PRODUCT BULLETIN: PB#B3006

DATE: May 9, 2003
REF: IFS1460 Suspensions
SUBJECT: Carrier Bolt Torque Revision
EFFECTIVE: Immediately

Figure 1. Location of 100039-P1 Carrier attachment bolts. Wheel end components removed for clarity.

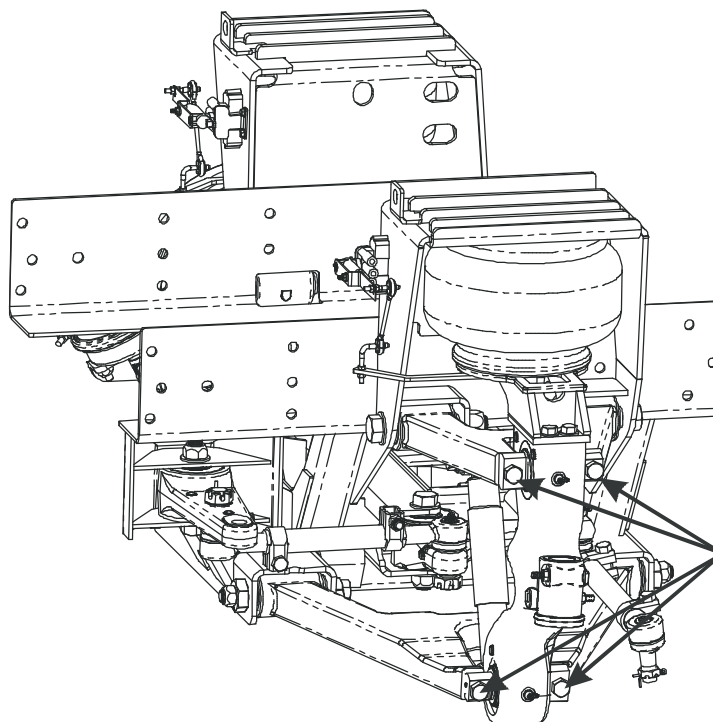
Tuthill Transport Technologies has revised the torque requirements of the IFS1460 Carrier attachment bolts (3/4"-10 Hex Head Bolt, part number 100039-P1) from 275-300 ft-lbs to **365-385 ft-lbs**.
